**Project/File:** **Plano Road Subdivision (SUB07-00065, CAR07-00042, CUP07-00084, CFH07-00022)**  
*This application is for preliminary plat, annexation, rezone, and hillside permit for 154 single-family homes on approximately 333 acres.*

**Lead Agency:** City of Boise

**Commission Approval:** June 25, 2008

**Tech Review:** April 11, 2008

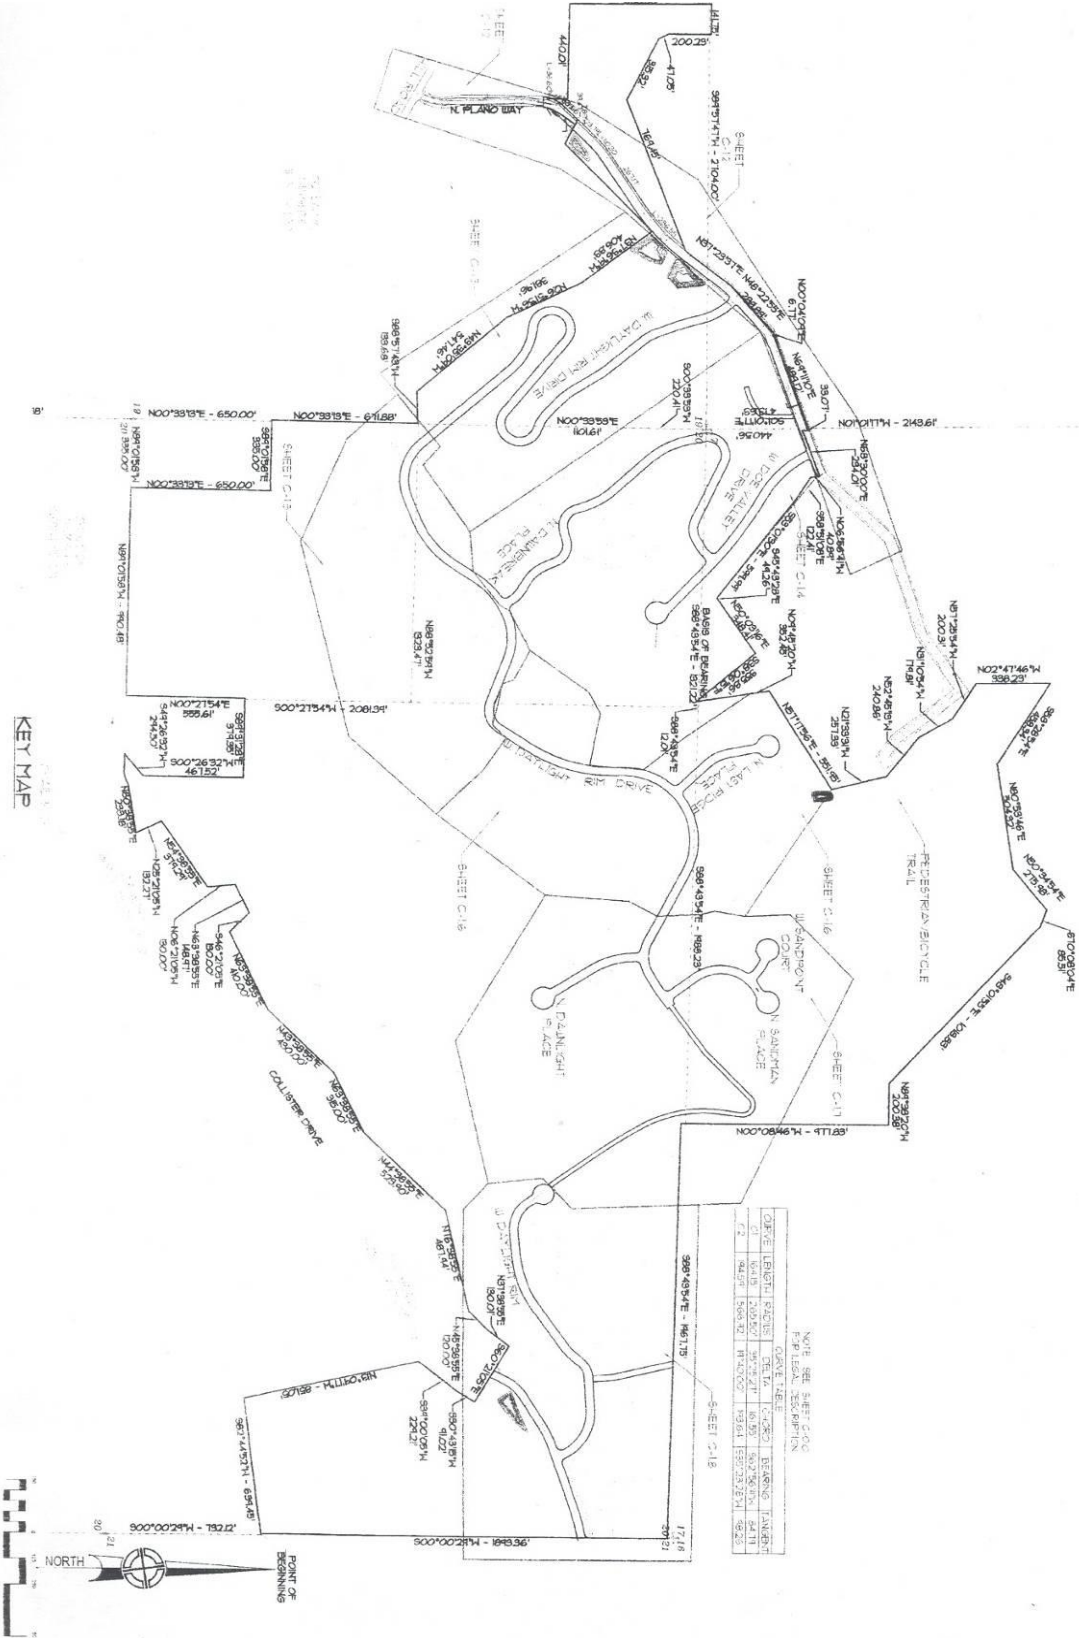
**Staff Comment/Recommendation:** Currently, six houses and a number of vacant lots either take access to or have frontage along the unimproved and unaccepted portion of Plano Lane that extends to and beyond the site. The applicant's proposal includes improving and realigning portions of this roadway. Any improvement or realignment must accommodate both existing access requirements and the potential extension of Plano beyond the site.

District staff recommends that the applicant extend and dedicate Collister Drive through the site and into the Polecat Gulch Reserve as a standard 36-foot street section with vertical curb, gutter and 5-foot concrete sidewalks on both sides, all within 50-feet of right-of-way. The 36-foot street section is consistent the street improvements on the existing section of Collister Drive and should be extended into the site. The applicant will be required to provide a minimum outside radius of 45-feet for the cul-de-sac turnaround. The applicant should coordinate with Boise City to provide a public turnaround easement covering the entire cul-de-sac. Access to any unpaved trail parking should be located at least 30-feet from the dedicated right-of-way.

**Staff Comment/Recommendation:** The topography of the site presents a challenge in ensuring compliance with District policy 7204.4 for local street design. The applicant's current plans propose five curves with centerline radii less than 100-feet (two on Daylight Rim Drive, three on Dawnbreak Place), and one set of reverse curves with a tangent length of less than 50-feet between them (on Daylight Rim Drive). The applicant will likely also need a variance for a centerline curve radius of less than 100-feet if it is to be a continuous public street as recommended.

The applicant should construct all internal streets as 29-foot street sections (back-of-curb to back-of-curb) with vertical curb and gutter on both sides, all within 40-feet of right-of-way. Additionally, the applicant should construct continuous 5-foot concrete sidewalk on one side of all internal streets, as well as sidewalk along all lot frontages with direct access to the street.

District staff recommends a modification of policy to allow the five curves with centerline radii less than 100-feet, the one centerline tangent length between reverse curves of less than 50-feet, provided all internal roadways meet AASHTO standards for a 20 MPH design speed. District staff recommends against any modification of policy to allow any centerline grade in excess of 10%.

17. Ensure that all street geometries comply with District policies 7204.4.8 through 7204.4.13, except where a modification of policy has been granted. Modification of policy has been granted for only the following:

- a. Centerline radius of 86-feet at Sta. 11+50 to 14+50 of Daylight Rim Drive.
  - b. Centerline radius of 86-feet at Sta. 19+00 to 22+00 of Daylight Rim Drive.

- c. Centerline radius of 86-feet at Sta. 305+50 to 307+00 of Buck Hollow Way.
  - d. Centerline radius of 86-feet at Sta. 314+25 to 315+50 of Buck Hollow Way.

- e. Centerline radius of 86-feet at Sta. 316+00 to 317+25 of Buck Hollow Way.
  - f. Centerline tangent length between curves of less than 50-feet at Sta. 22+21.16 of Daylight Rim Drive.
